ADDENDUM #2

Date: May 25, 2020

PACIFIC REGION
PORT HARDY LOGISTICS DEPOT
PORT HARDY, B.C.
Project No: 8H500

1:100
 Project No./No. du projet
1691-017
 DATE
 2020-01-20
 Sheet/Feuille
S203
 Revision no./
 Révision no.
2

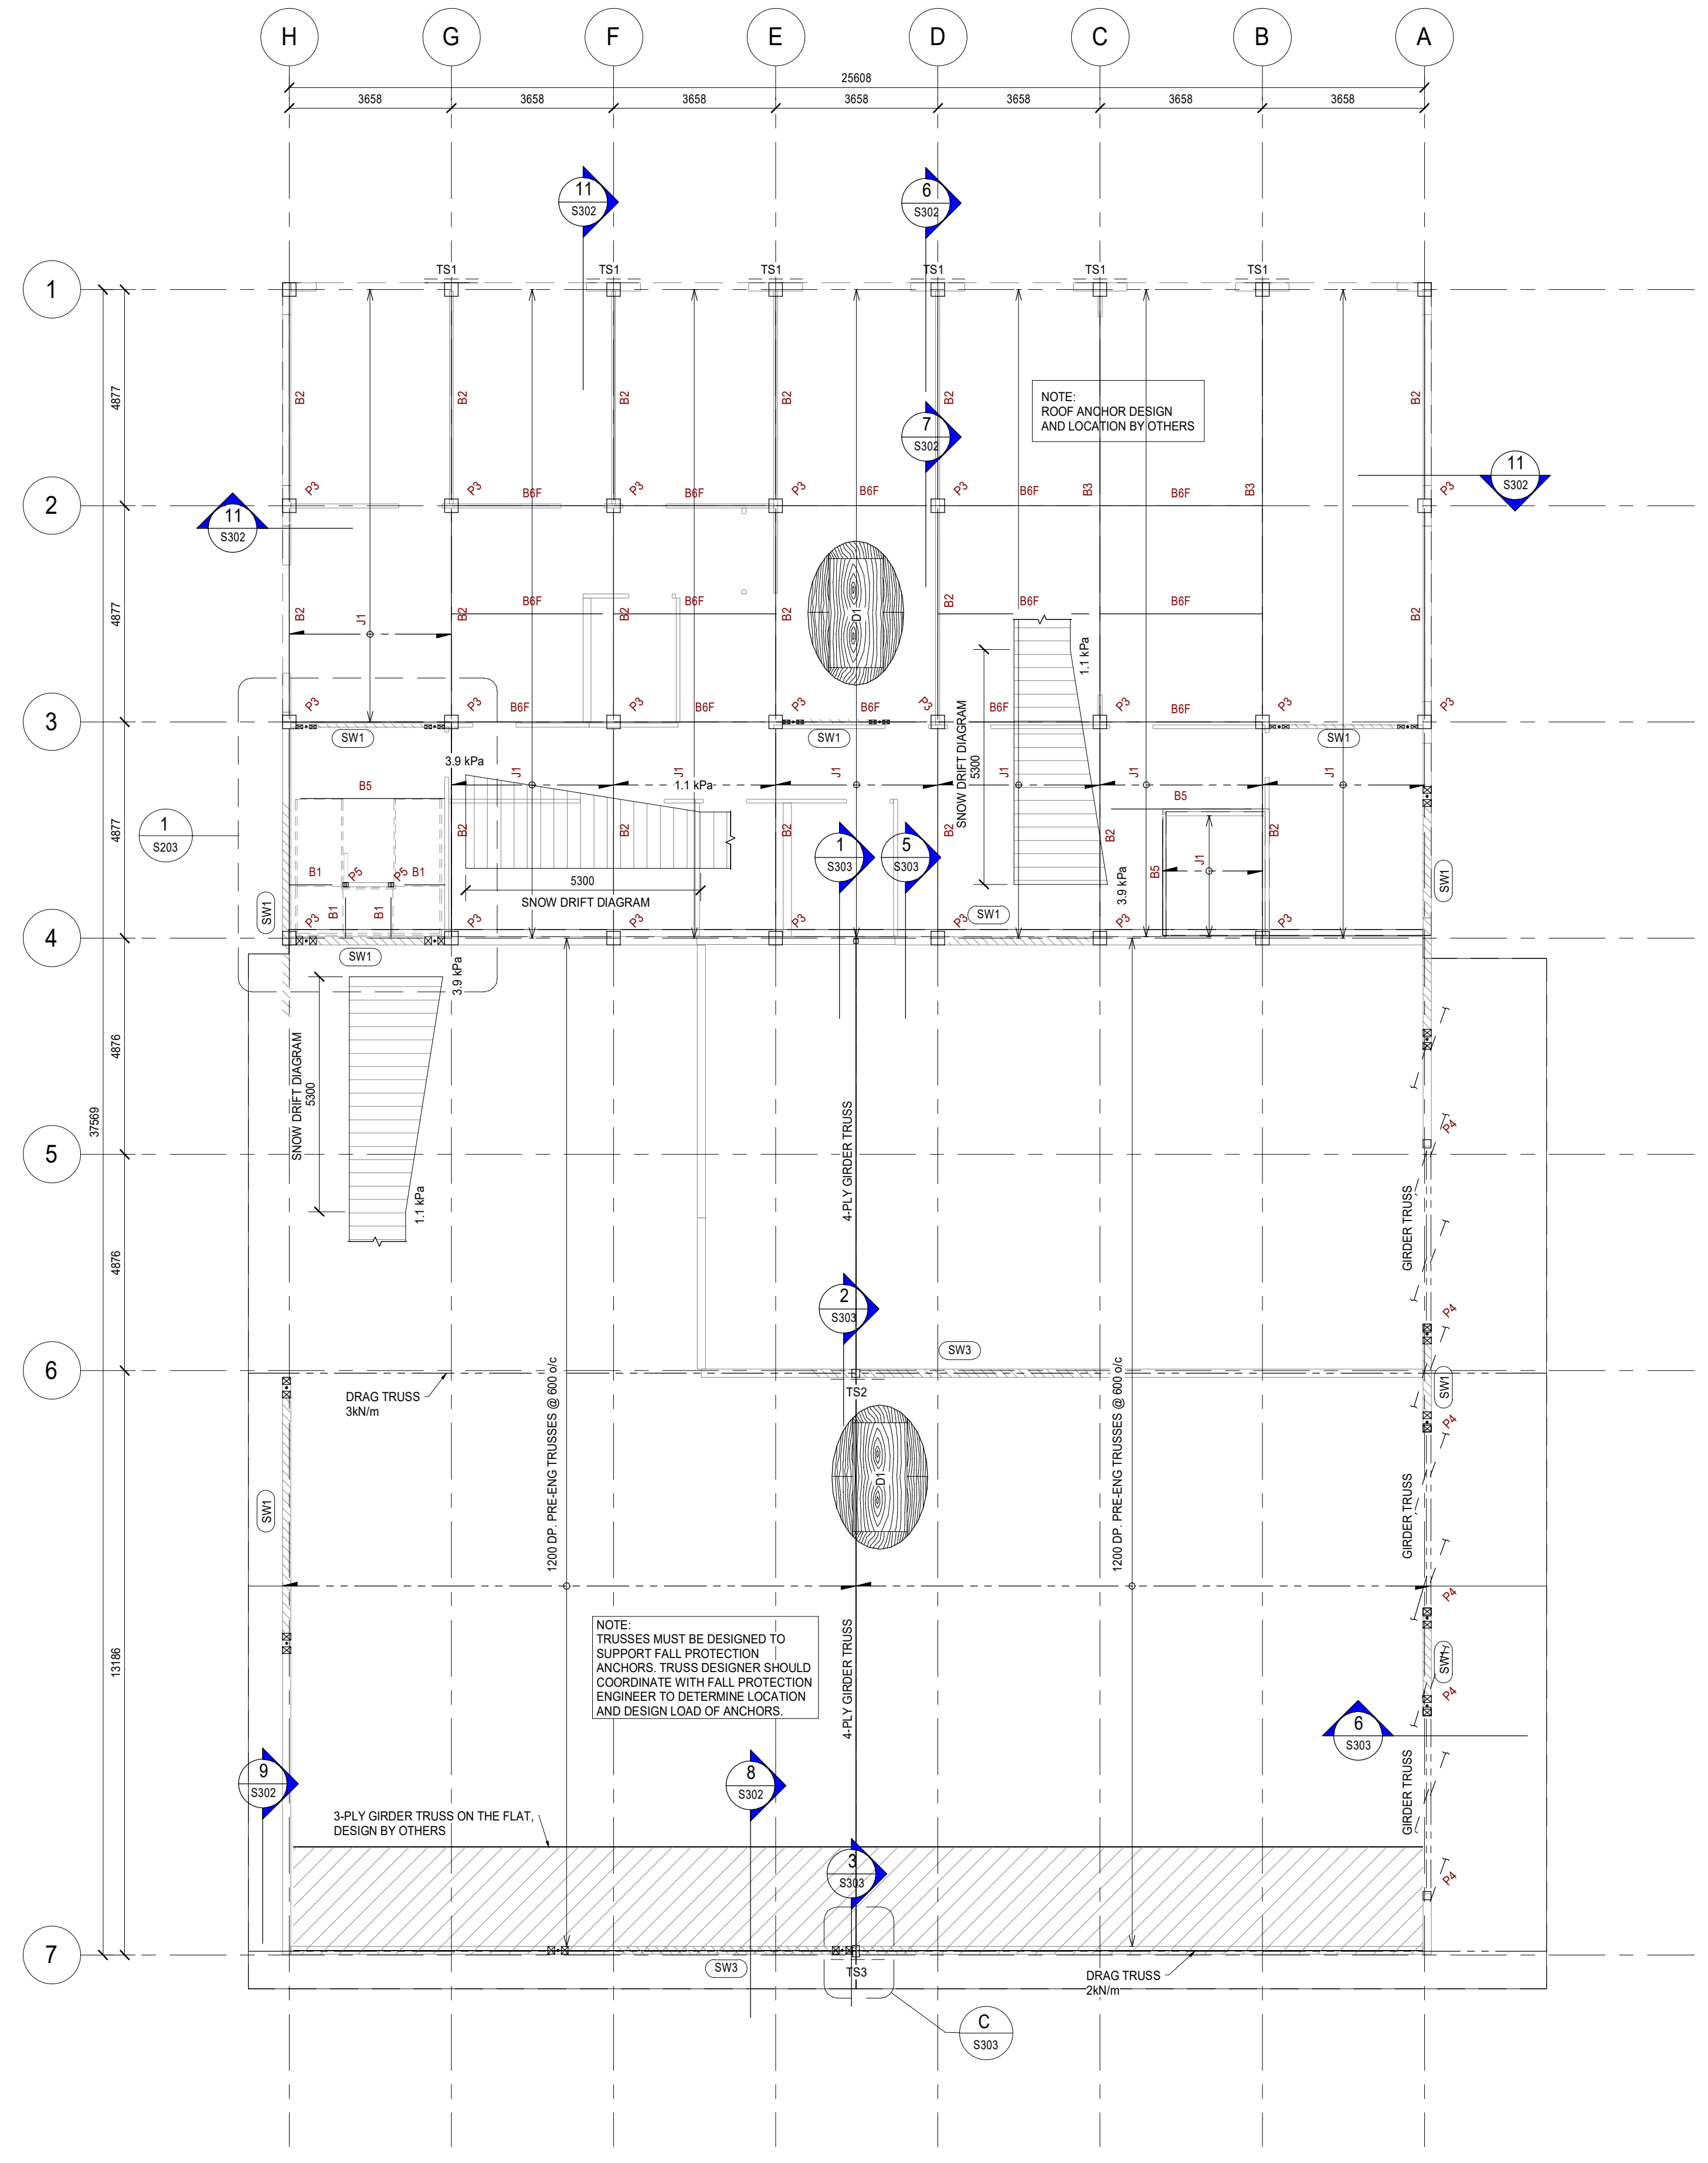
Q.14 Structural Drawing S203 - Can the 3 ply girder on the flat along grid line 7 be built in 2 or more pieces? as it's about 84' long otherwise?

Q.15 Structural Drawing S203 - Can you give me more detail for the drag truss/girder trusses along gridline A?

Q.16 Structural Drawing S203 - Is the drag truss meant to be continuous from gridline 4-7?

- Q.17 Structural Drawing S203 - Would there be separate girder trusses only over the openings to support the trusses, could those be replaced with LVL?

A.14 Yes.

A.15 All trusses to be detailed by truss manufacturer.

A.16 No, not as a single truss.

- A.17 Girder trusses run along column line A from column line 4 to column line 7. Please bid project as designed.
- Q.18 Drawing A-12; Detail 2 - Please can you confirm if the upper roof drain weir runs across the full length of the roof as indicated on the roof plan or in 1500mm long sections as shown on detail 2.
